SERVICE BULLETIN

FUJI HEAVY INDUSTRIES LTD.

NO : FAS-046

Extension of the time required to spin.

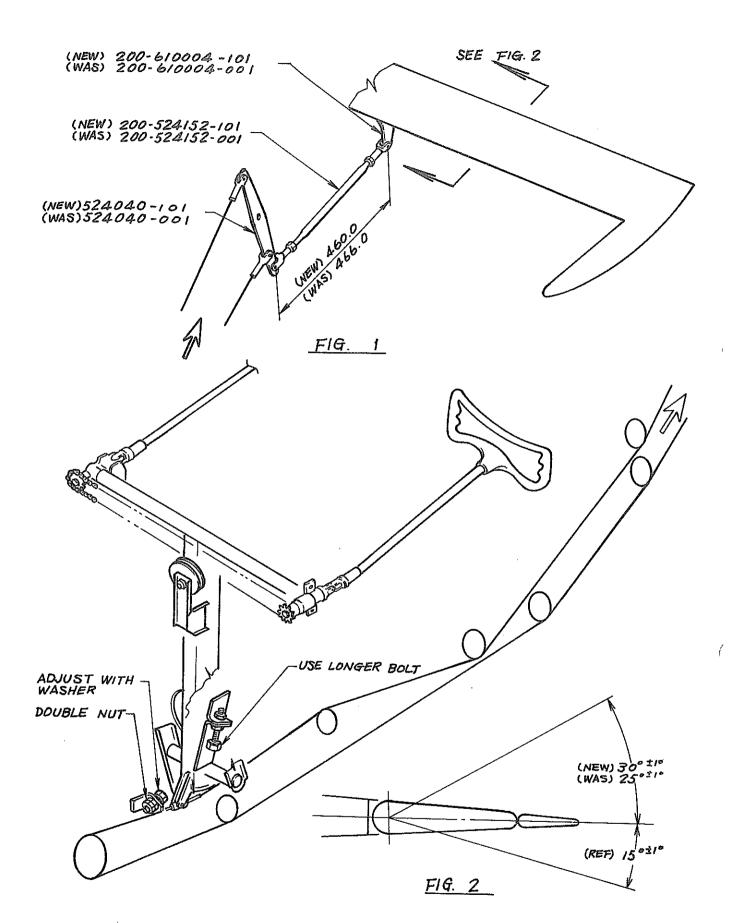
13. DETAILED INSTRUCTIONS: Replace the bell crank, rod assy and horn bracket in zone of the connection of elevator control surface

with new ones and alter adjusting screw of stopper

in lower position of control stick.

- i. Stopper adjustment mechanism of the control stick are reconstructed as follow. (See Fig. 1)
 - (a) Remove the lower access cover (2)(7) in the cockpit as shown in Service Manual Fig. 3-5.

- (d) For elevator angle adjustment of control surface, the stopper in lower section of control stick (See Fig. 2) serves for adjustment of elevator angle to up 30° and down 15°.
